Subject: Response to U.S. EPR Design Certification Application RAI No. 547 (6499, 6359), FSAR Ch. 3 - NEW PHASE 4 RAI, Supplement 6 - Part 1 of 4
Sent Date: 4/29/2013 5:18:22 PM
Received Date: 4/29/2013 5:20:57 PM
From: WILLIFORD Dennis (AREVA)

QUESTIONS for Structural Engineering Branch 2 (ESBWR/ABWR Projects) (SEB2)

Question 03.07.02-78**Open Item****Follow-up to RAI 371, Question 03.07.02-66 and RAI 376 Question 03.08.05-28.**

Figure 3.7.2-78-38: Inner Q1 – Soil 1n2ue, 2sn4uem, 4uem & 1n5aeh (Cracked Concrete Case)

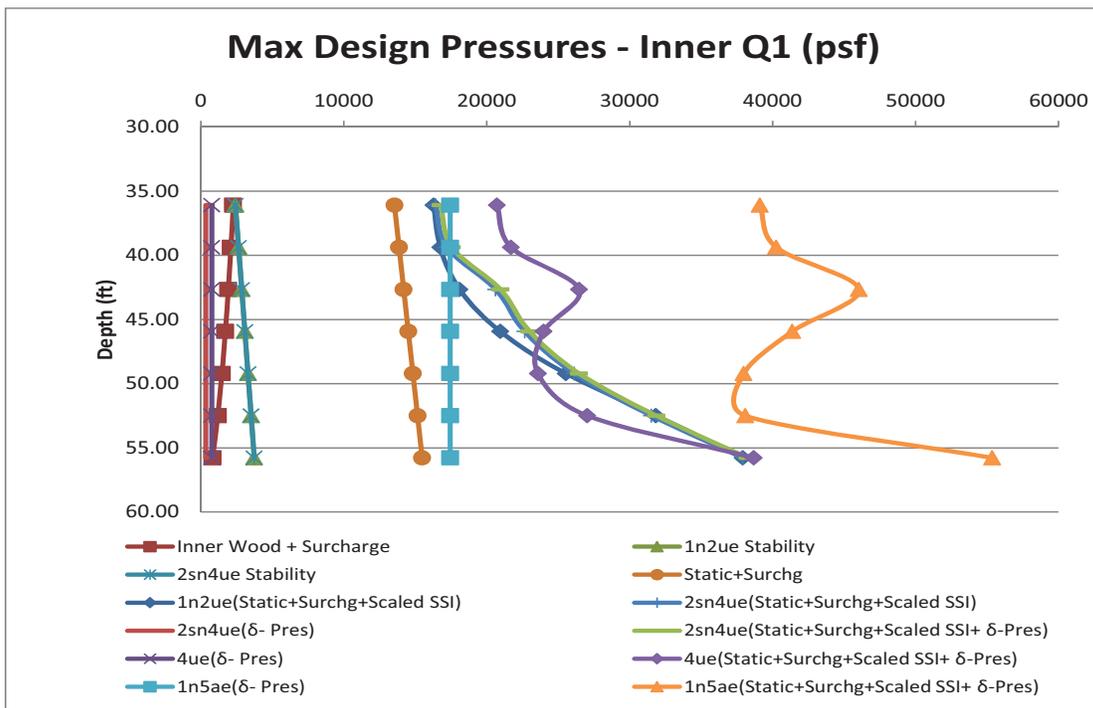
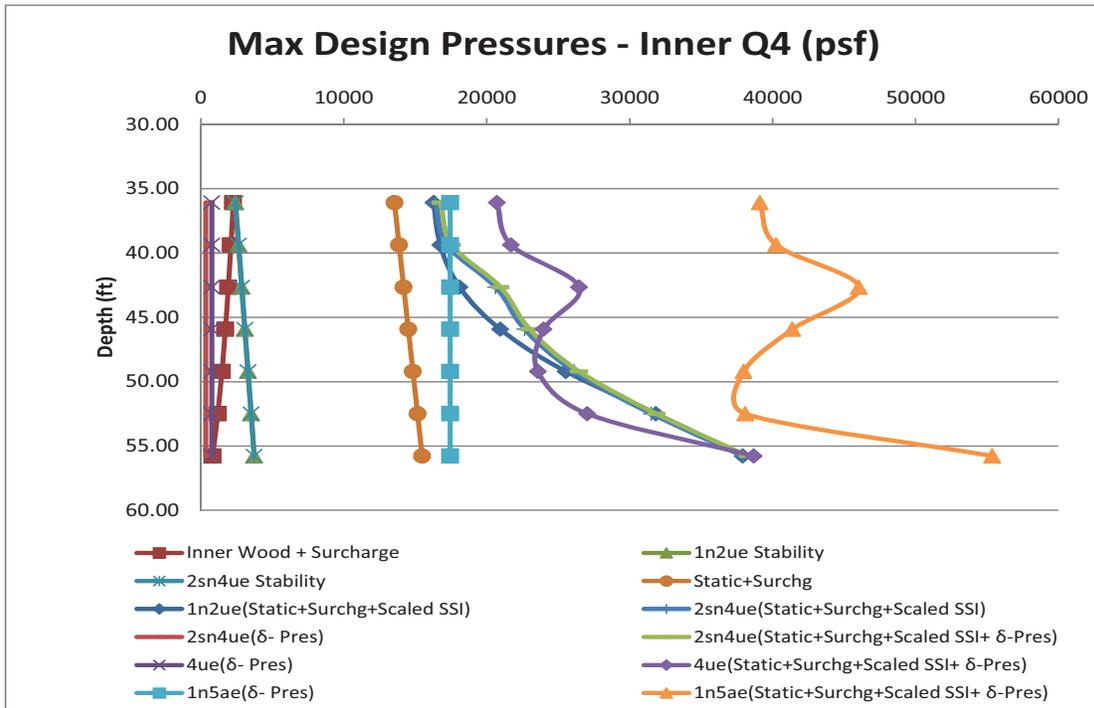
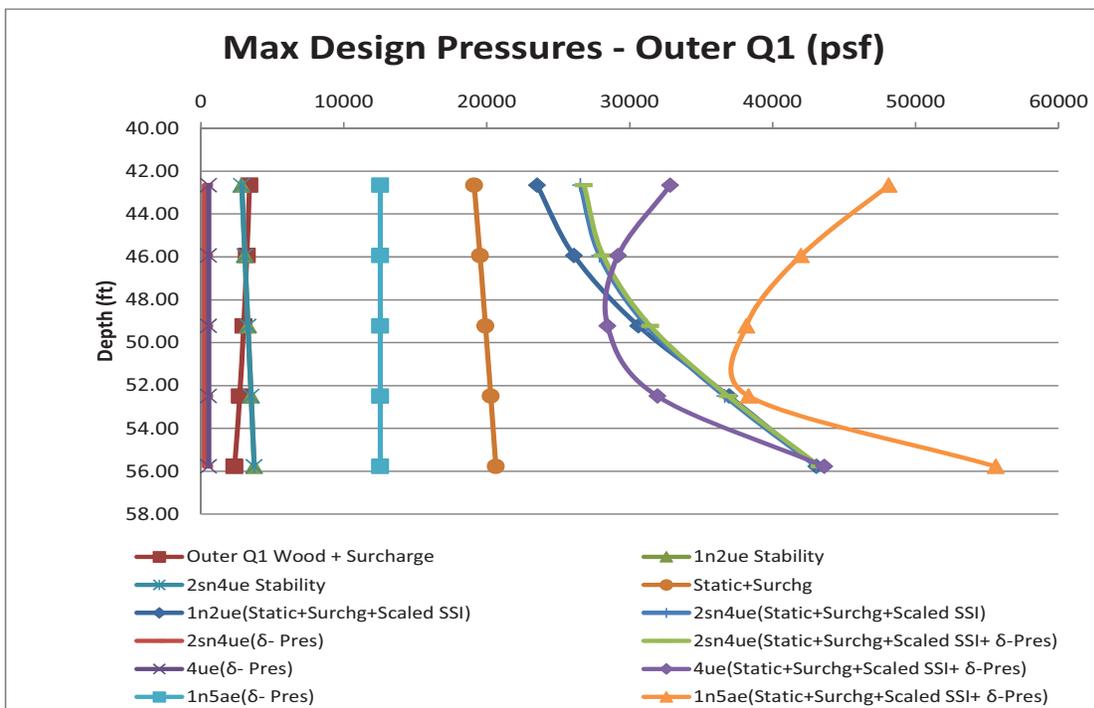
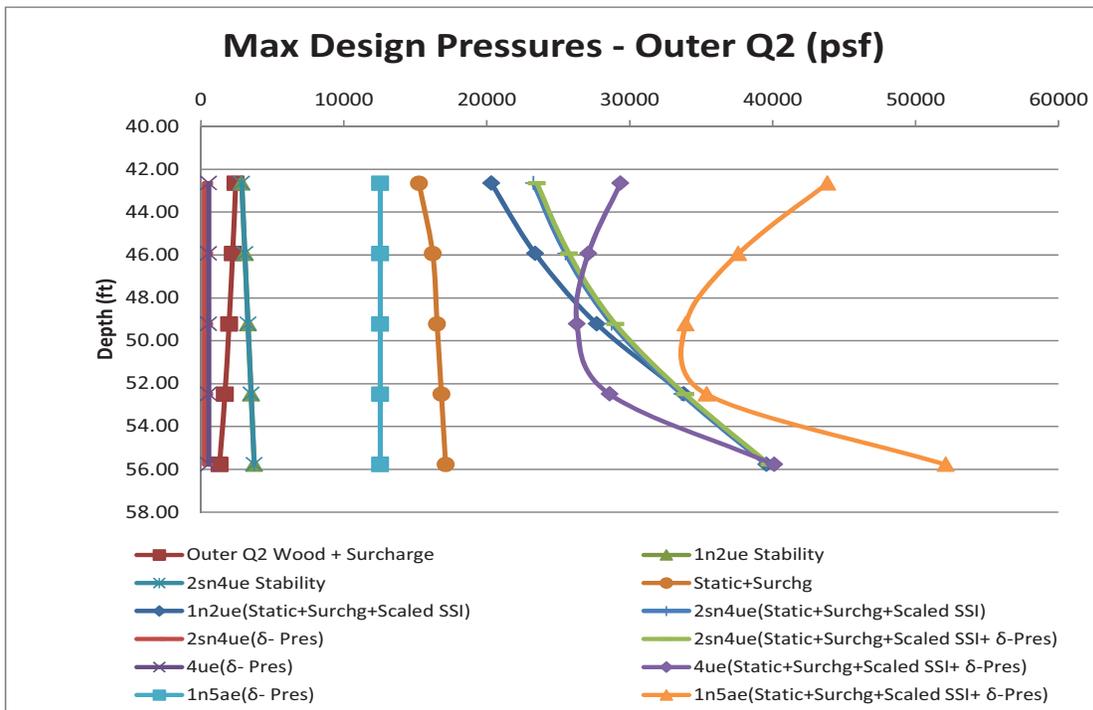
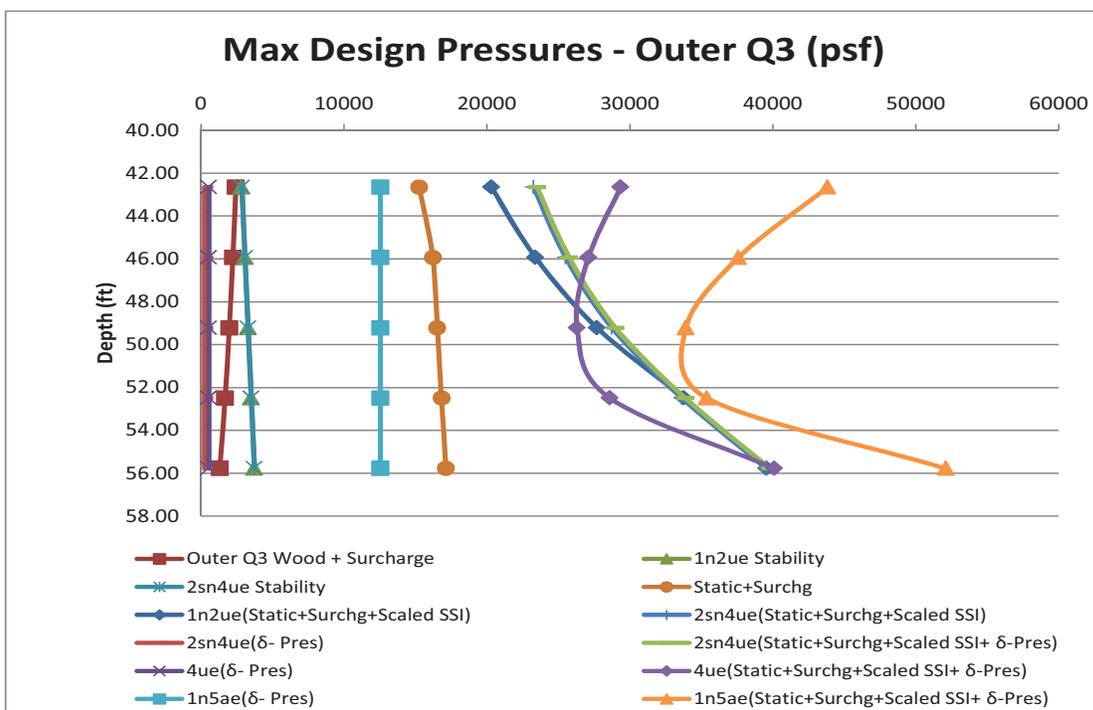
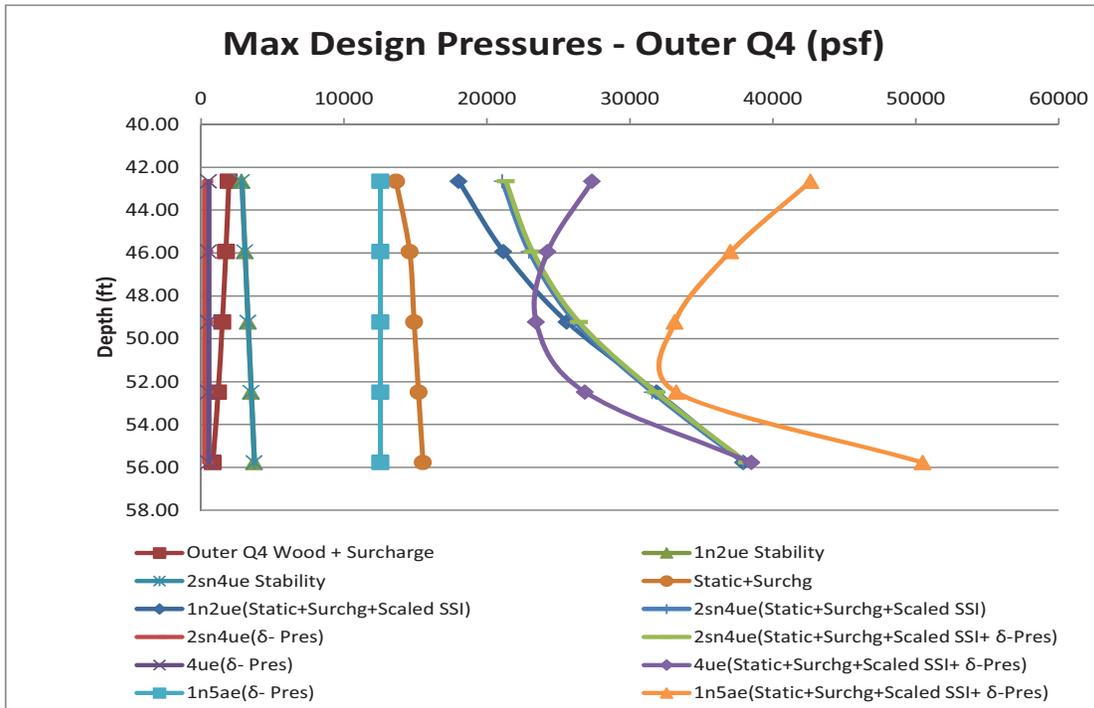
The response to RAI 376 Question 03.08.05-28 provides figures showing the lateral pressures used to design the tendon gallery sidewalls. However, Figures 3.8.5-28-34 through 3.8.5-28-41 ("cracked" seismic analysis case) only show results for soil cases 1n2ue and 2sn4uem, while Figures 3.8.5-28-90 through 3.8.5-28-97 ("uncracked" seismic analysis case) only show results for case 4uem. Provide updated figures which include all relevant soil/rock cases, including the rock cases 1n5aeh and 5aeh, which appear to result in the highest sidewall pressures (as described in the response to RAI 371 Question 03.07.02-66 Item (a)). Also, add the additional pressures due to the localized sliding/uplift of the basemat (i.e., the "delta pressures" described in the response to RAI 371 Question 03.07.02-66, listed in Tables 03.07.02-66-1 and 03.07.02-66-2) that were not included in the figures. The information provided should be consistent with the information requested under Question (1) of this RAI.

The BMAT model is used to derive the additional pressures on the TG due to lifting/sliding of the basemat. As stated in response to Item 2(g) of the RAI, static soil springs are used with the BMAT model to generate the forces and moments in the basemat due to various static load cases. The BMAT model with dynamic soil springs, derived using Gazetas method, was used to generate the delta pressures corresponding to the lifting/sliding of the basemat due to dynamic (seismic) loads.

Figure 3.7.2-78-56—Bearing Pressure Distribution for Foundations

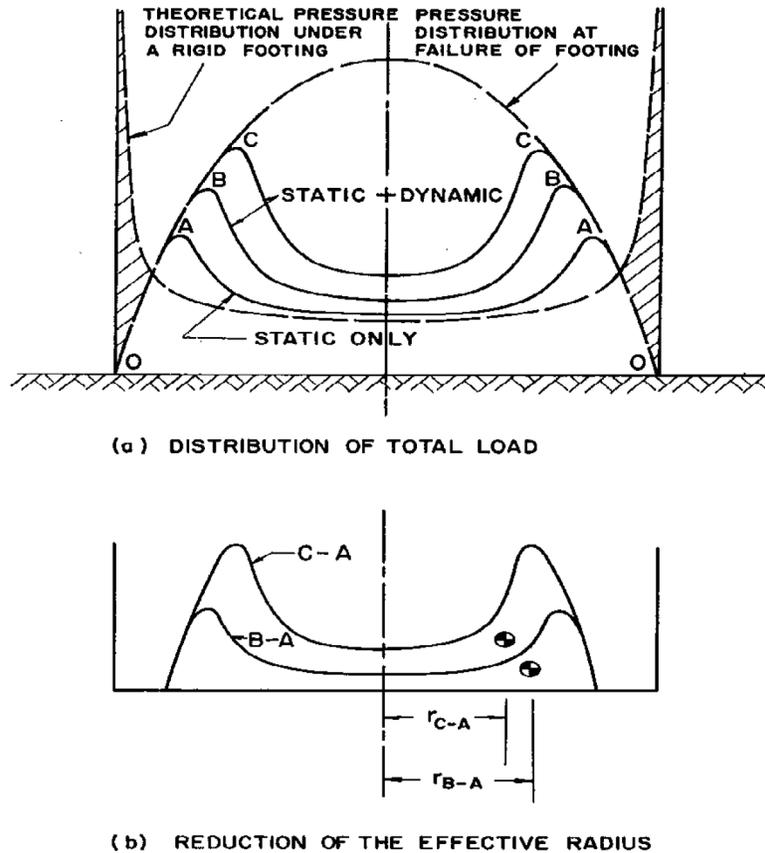
- (b) For the bearing pressure contour plots shown in Figures 3.8.5-28-A through 3.8.5-28-D, provide the technical basis for the process used to average the corner pressures, toe pressures, and any other localized pressure “hotspots.”

- (b) As reported in technical literature (see F.E. Richart and R.V. Whitman, "Footing Vibrations – Comparison of Test Results with Theory," University of Michigan, IP-755, November 1966) theoretical equations result in very high bearing pressures near the edges of the footing due to singularity. The authors present a more credible bearing (failure) pressure distribution shown in Figure 3.7.2-78-56 (reproduced from Richart's paper). In accordance with the postulated pressure distribution for combined static and dynamic loads, the bearing failure point moves away from the edge of the footing. Though the paper does not provide specific guidelines for averaging pressures near the edges (and corners), it does point to the need for a more realistic treatment of the theoretically derived peak pressures near the edges; and, thus, any FEM analysis. Therefore, averaging of the bearing pressures over the corner and edges of the basemat is considered to be a reasonable approach to estimate the corner and edge pressures.

Figure 3.7.2-78-57: Case 1n2ue, Cracked, Time Snapshot of the Dynamic Bearing Pressure at Max Dynamic Bearing Pressure Time(s)

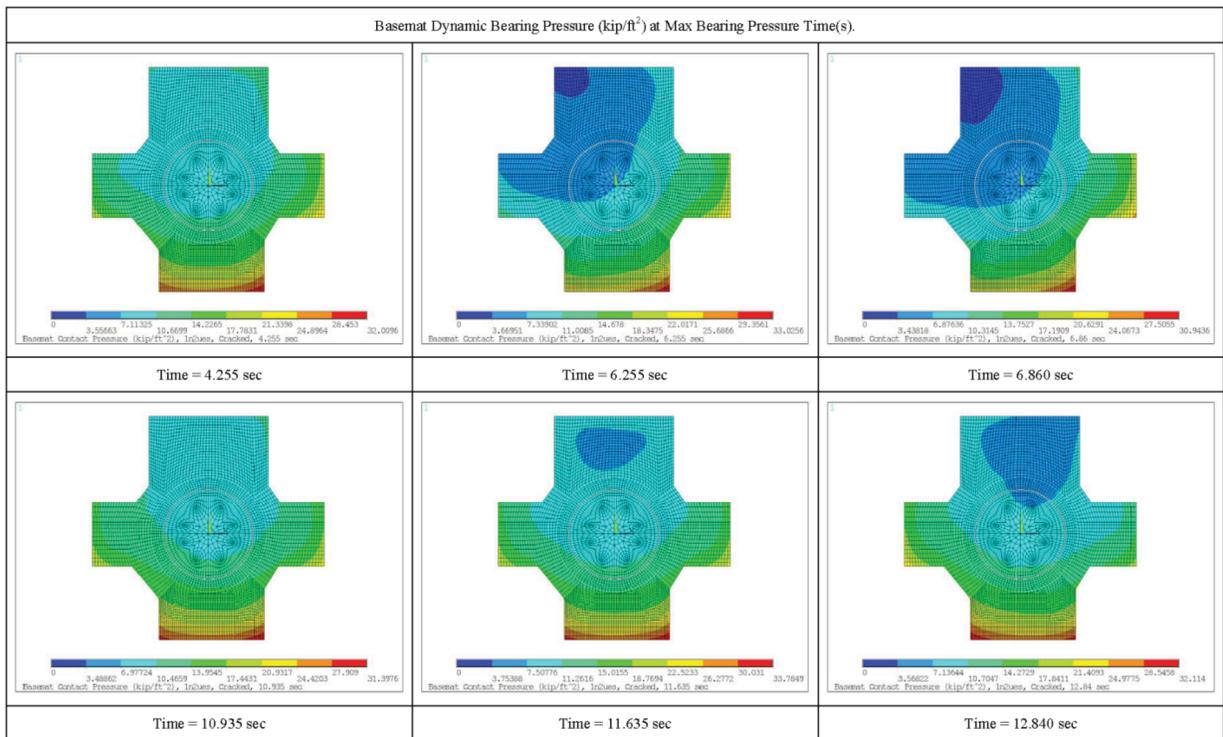
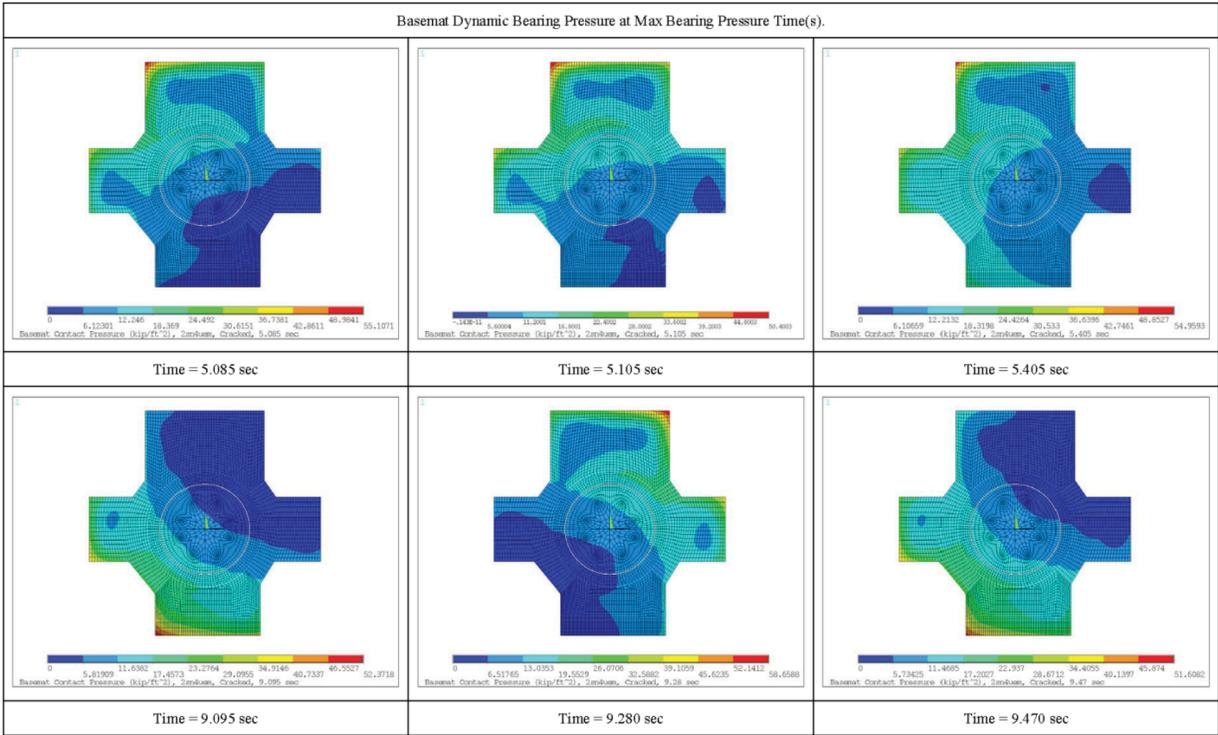
- (d) Item 5(e) of the RAI response indicates that the ANSYS 3D FEM basemat model results were compared to the SASSI FEM model results. Since the reported bearing pressures are obtained from the SASSI FEM model results, provide bearing pressure contour plots similar to those in Figures 3.8.5-28-A through 3.8.5-28-D, obtained from the ANSYS 3D FEM basemat model. Discuss the comparison between the two sets of results.

(d) Bearing pressure contour plots generated from the ANSYS 3D FEM basemat model are shown in Figure 3.7.2-78-57 through Figure 3.7.2-78-60. These contour plots correspond to soil cases 1n2ue, 2sn4uem, 4uem, and 5aeh, respectively; and correspond to the SASSI-generated contour plots with similar soil cases shown in Figure 3.8.5-28-A through Figure 3.8.5-28-D in the Response to RAI 376, Question 03.08.05-28. The contour plots shown for the ANSYS results represent the bearing pressures without any averaging, whereas the SASSI contour plots show averaged corner and edge pressures. The two sets of results are comparable.
